**YPSILANTI
TOWNSHIP**
— PLANNING & ZONING DEPARTMENT —

REGULAR MEETING AGENDA

Tuesday, July 28, 2026

- B. **PRELIMINARY SKETCH PLAN REVIEW – KALLITA TURBINES – 2830 TYLER RD –** TO CONSIDER THE CONSTRUCTION OF A 12,000 SQUARE FOOT STORAGE BUILDING ON A 9.8 ACRE SITE ZONED I-C, INDUSTRIAL AND COMMERCIAL

SHEET TITLE
SITE PLAN

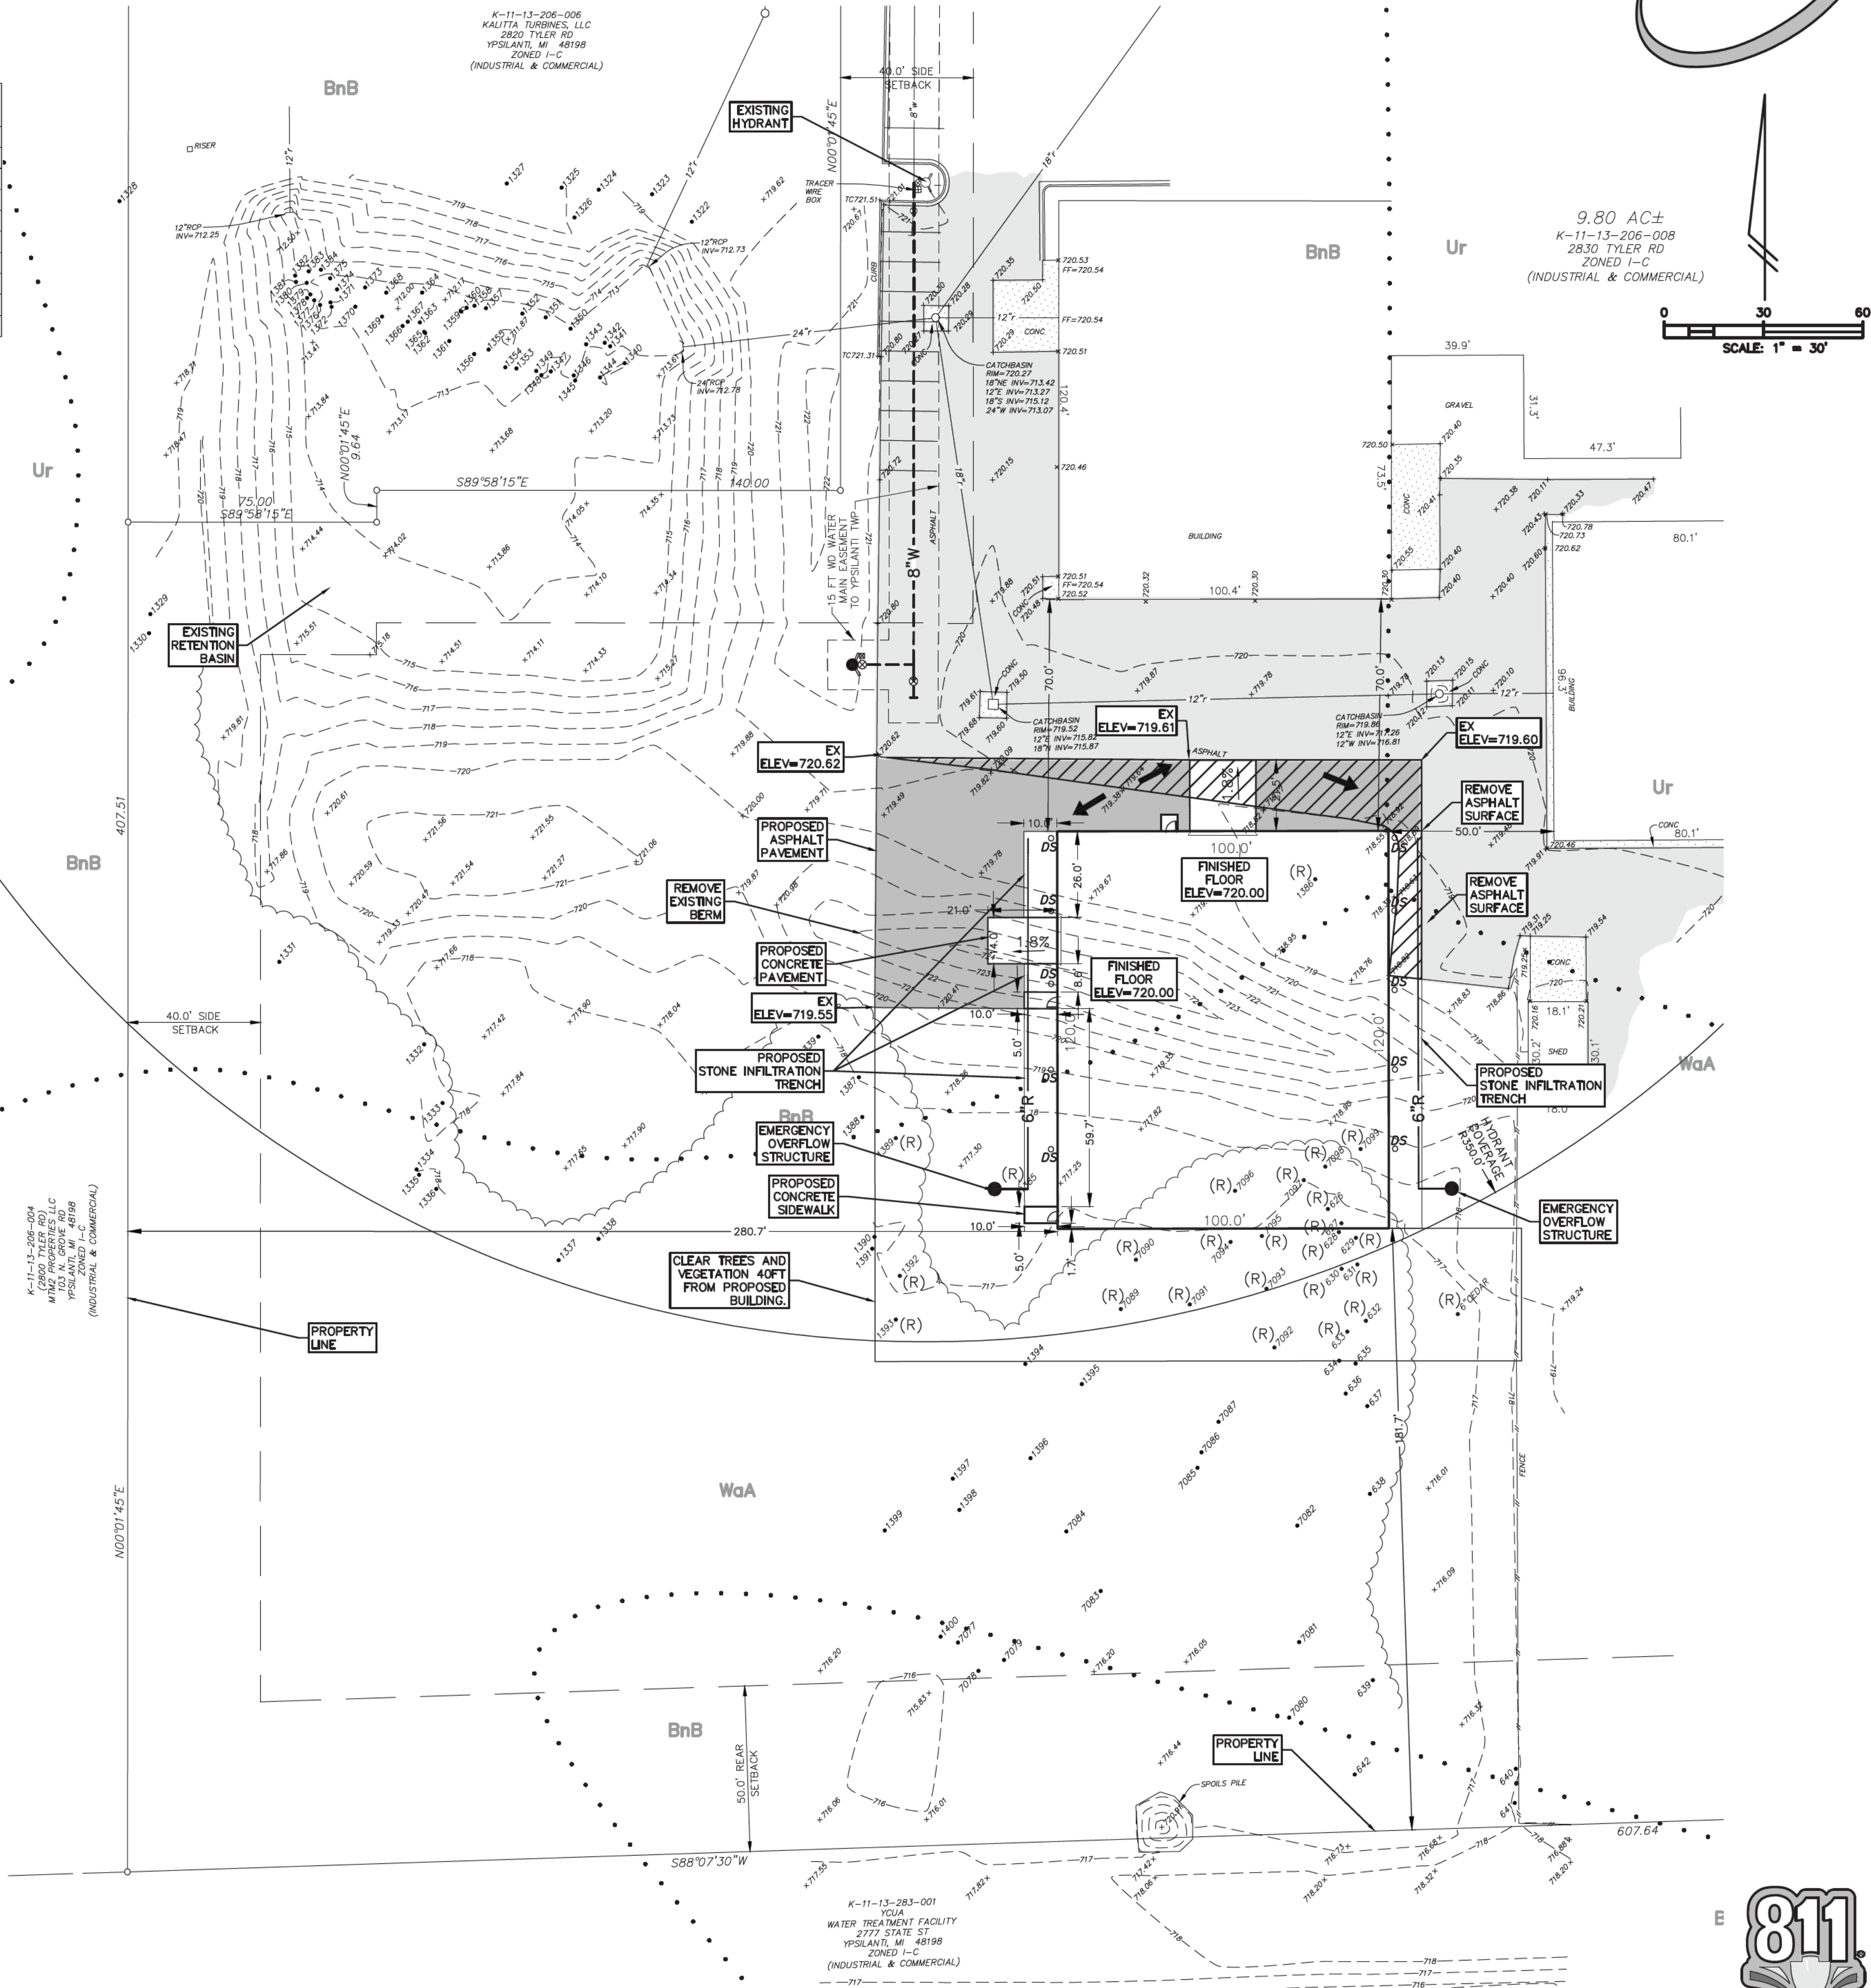
Woodlands: Sheet C3.0, *Site Plan*, shows the location of 15 trees 8-inch DBH or greater to be removed, as well as a table describing the species, size and condition of the trees to be removed. Sec. 24-67 of the Woodlands Protection ordinance does not require mitigation for tree removal within the limits of construction.

SHEET TITLE
GRADING AND SOIL
EROSION CONTROL
PLAN

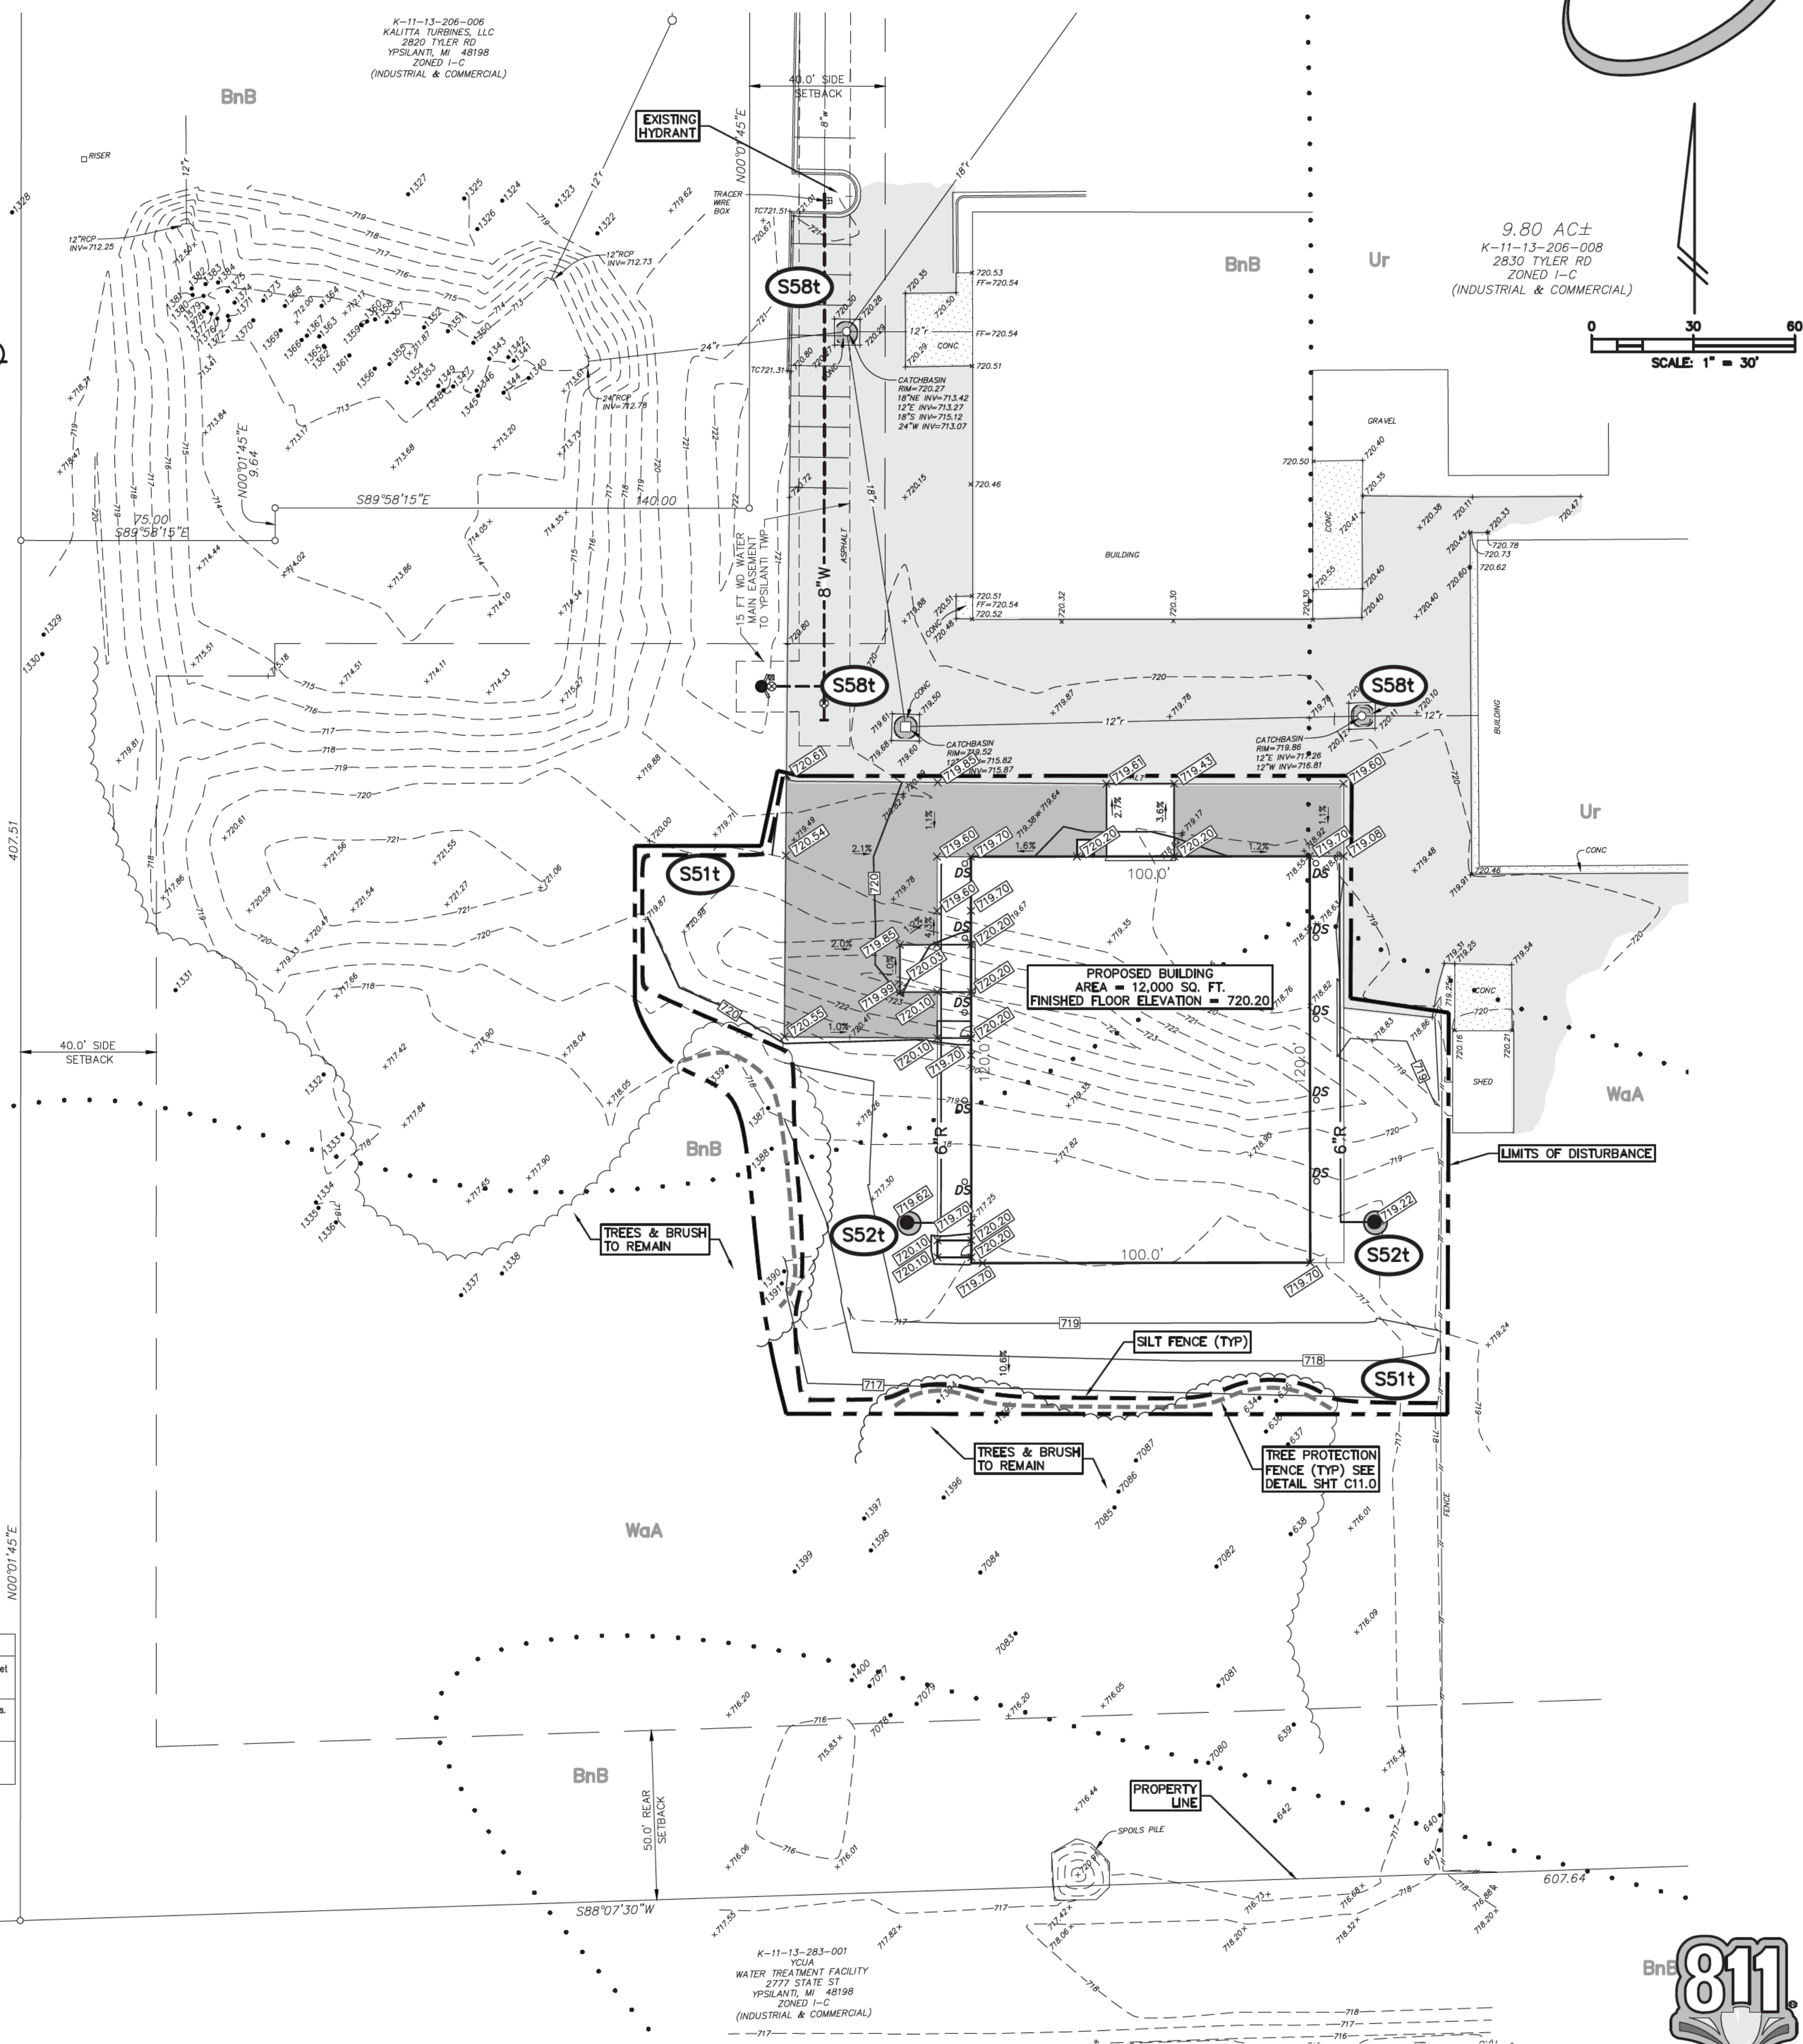
1. Show Tree Protective Fencing symbol around all "trees and vegetation to remain" on Site Plan and Grading Plan.
Tree protection fencing and detail added to sheet C11.0.

2. Add Tree Protection Fencing detail to plans.
Tree protection fencing and detail added to sheet C11.0.
3. Include following note on Site Plan and Grading Plan, "No vehicle, other construction equipment, or construction materials or debris shall be parked or stored within the dripline of any tree or plant material intended to be saved".
Note added to sheet C4.0 under notes #7.

The storm water maintenance plan is shown on the grading and soil erosion control plan sheet C4.0.
